INDESIT company

Model type:
AVXL105EX

Commercial code:
F029660

n1040306: Reduction of cabinet depth on ARISTON EVOII 6kg washing machines produced at Bre

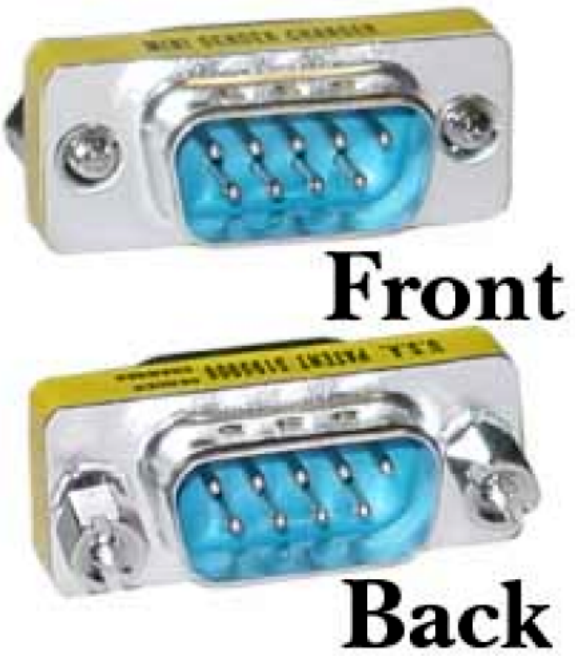
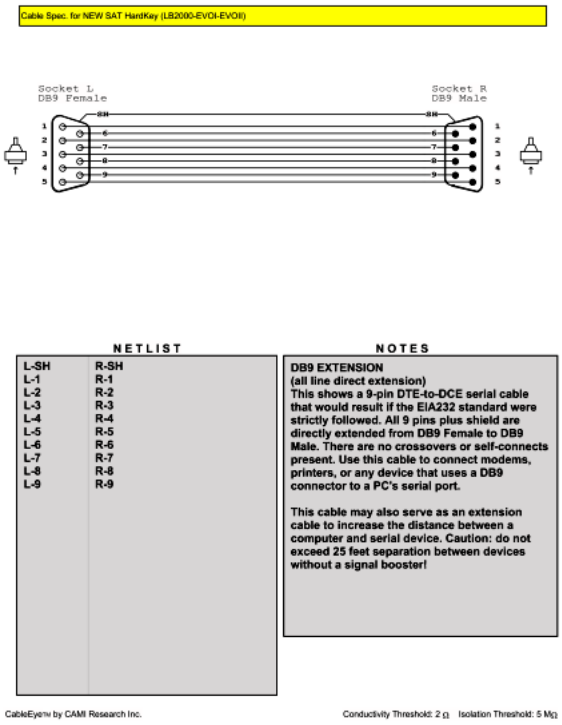
From serial no. 30915.0001, ARISTON EVOII 6kg washing machines affected by this note have been modified due to the reduced depth of the cabinet.
The modified models have a new industrial code.
The items affected by the modification are: cabinet, packing kit, top, product dispenser lid (including solenoid valve) and

solenoid valve.
Regarding the packaging kit, top, product dispenser lid and solenoid valve, the Replacements Warehouse will continue to manage premodification and new parts.
The premodification cabinets will be managed while stocks last, after which, in case of cabinet replacement the new cabinet, top and solenoid valve must be used, referring to the spare parts list for the relevant model.
Given below is a list of models affected by the modification with relevant new and premodification parts:

AVXD109EU (industrial codes: new 91296210001, premodification 91296210000);
AVXD129EX (industrial codes: new 91296220001, premodification 91296220000);
AVXL105EX (industrial codes: new 91296600001, premodification 91296600000);
AVXL109R (industrial codes: new 91297720001, premodification 91297720000);
AVXL89EU (industrial codes: new 91296230001, premodification 91296230000);
AVXD129EU (industrial codes: new 91284980101, premodification 1284980100);
AVXL109EU (industrial codes: new 91296240001, premodification 91296240000);
AVXD125FR (industrial codes: new 91284990101, premodification 91284990100);
AVXL100FR (industrial codes: new 91295430001, premodification 91295430000);
AVXL120FR (industrial codes: new 91295430001, premodification 91295430000);
AVXL88IT (industrial codes: new 91295180001, premodification 91295180000);
AVXL108IT (industrial codes: new 91284970101, premodification 91284970100);
Cabinet: premodification 095747, new 097709;

Packing kit: premodification 095741, new 094777;
Top: premodification 095738, new 097710;
Product dispenser lid (including solenoid valve): premodification 095740, new 097711;
Solenoid valve 1E2U: premodification 095739, new 097712.

AVXL105TK (industrial codes: new 91284830101, premodification 91284830100);
Cabinet: premodification 095747, new 097709;
Packing kit: premodification 095741, new 094777;
Top: premodification 095738, new 097710;
Product dispenser lid (including solenoid valve): premodification 096021, new 097715;
Solenoid valve 1E2U: premodification 095739, new 097712;
Solenoid valve 1E1U: premodification 096022, new 097716.

Fig. n10402231

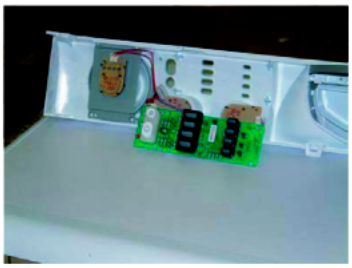
From serial no. 40429.0001, models AVL, AVXL, AVSL, AML have been equipped with a new panel with well holes for the ON/OFF and RESET buttons and flush plastic light diffusers in place of the projecting siliconed ones (see picture n10402231 Fig.02). These features determine whether an appliance is modified or premodification.
The modification has also involved the electronic card whose panel and display communication connectors are on the left and not at the back (see picture n10402232 Fig.2).

For both models
C00143338 - LED CARD EVOII AVL /BUILT-IN ARISTON
C00110115 - WHITE BUTTONS ON-OFF/RESET EVOII LED KIT
C00109854 - PANEL WIRING LBE EVOII
C00110055 - SILICONED BUTTONS AVL-AVSL
C00110059 - PANEL WIRING -DISPLAY 240000848B2.
C00111227 - WIRING MAIN - DISPLAY 24000084804B1 (POLARIZED).
The new parts are only interchangeable with the pre-modification ones if used altogether. They are not individually interchangeable.

n1040381: Drain pump with bayonet-style filter - front Loading Brembate

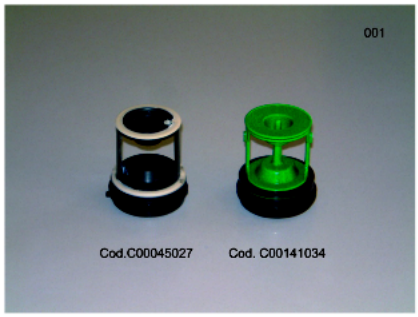
From serial no. 50720.0001 a new drain pump with bayonet-style filter has been installed on all front loading washing machines manufactured in Brembate.

New parts:
C00119307 - Drain pump
C00141034 - Pump filter kit

Premodification parts:
C00092264 - Drain pump
C00045027 - Pump filter kit

The new parts can be used instead of premodification ones.
